# UNITED STATES PATENT AND TRADEMARK OFFICE

APPLICATION NO.	FILING DATE	FIRST NAMED INVENTOR	ATTORNEY DOCKET NO.	CONFIRMATION NO.
10/058,643	01/28/2002	Anthony Nocella III	984	3850

**Office Action Summary**

### **DETAILED ACTION**

Fig. 1

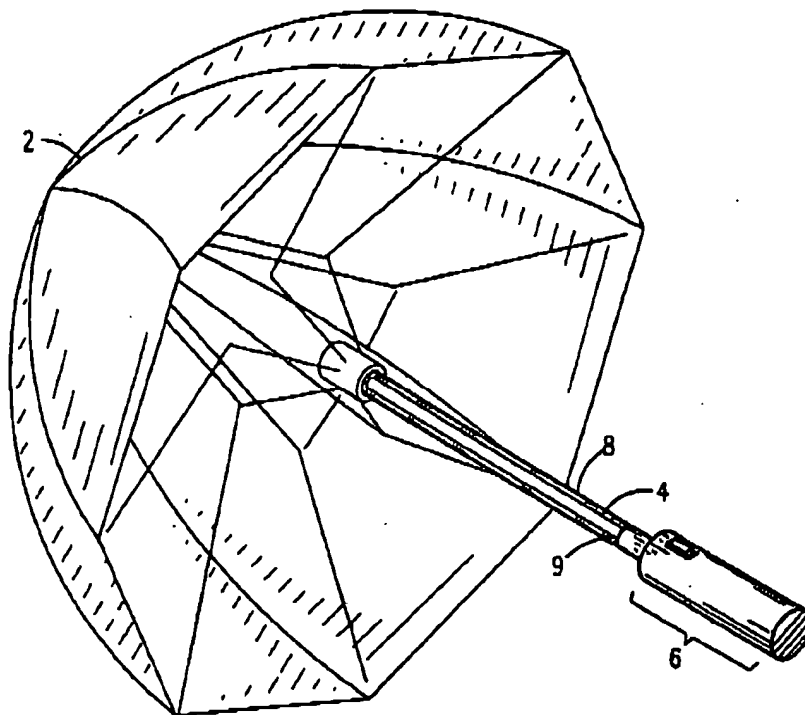
CFR 1.83(a). The drawings must show every feature of the invention specified in the claims. Therefore, the feature of “an illumination means housed within said shaft” (claim 1) “the illumination means comprises and incandescent lamp” (claim 3) must be shown or the features canceled from the claims. No new matter should be entered.

disapproved  
mg  
8/25/05

Fig. 2

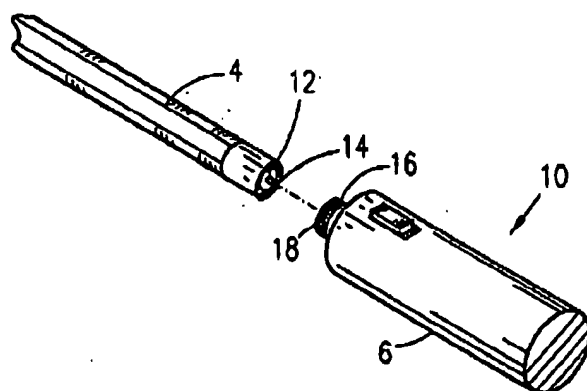
1. The drawings correction filed June 21, 2005 are disapproved because they include a new matter which is not originally filed.. The new subject matter is: the proposed drawing Fig. 2 changes the batteries (12) being located on the lower end of the shaft and the end cap at the upper end of the handle section which are not supported by either the specification and the drawings as originally filed. According to the disclosure, page 5, lines 11-17, and the drawing Fig. 2 as originally filed, the batteries 12 “are stored within a cavity inside of the handle section (10), “a series of threads 14 are formed along the lower rim of the handle, and “a screw cap 16 with matching, receiving the threads 18 mate to the threads 14 to removably contain the batteries 12”. The proposed drawing Fig. 2 provides a new position of the barriers 12 and the cap 14 as different then Fig. 2 as originally filed. New matter must be cancelled.

disapproved  
w/ 8/25/05
